City of Keene Planning Board

AGENDA - AMENDED

Monday, July 22, 2024

Figure 2. A snippet of Sheet 2 of the plan set showing the location of the wetlands and 75' wetlands buffer.

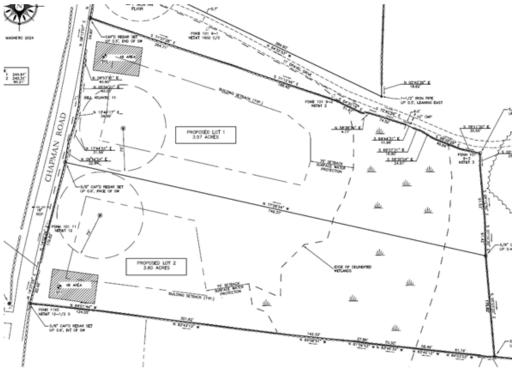
20.2.2 - Character of Land for Subdivision: Wetlands are located towards the rear of the proposed 3-ac lots (Figure 2). Additionally, the project narrative states there are areas of precautionary and prohibitive slopes present at the rear of the 40.63-ac parcel that were not surveyed due to their location outside of the proposed subdivision area. Despite these site features, the proposed plans show that the two new lots can be safely developed without posing a danger to health or peril from fire, flood, poor drainage, excessive slope, or other hazardous conditions. This standard appears to be met.

21.11 - Surface Waters & Wetlands: As discussed above, Sheet 2 of the plan set shows that there are surface waters present at the rear of the two 3-ac parcels and also shows the 75' surface water buffer that must be maintained from the edge of the wetlands. Note #4 under the "Site Development Standards" on Sheet 1 of the plan set specifies that any development in these areas must comply with local, state, and federal wetlands regulations. Planning Staff recommend two conditions of approval related to the submittal of a stormwater management plan and flagging of the wetlands prior to the development of either of the new lots. This standard appears to be met.
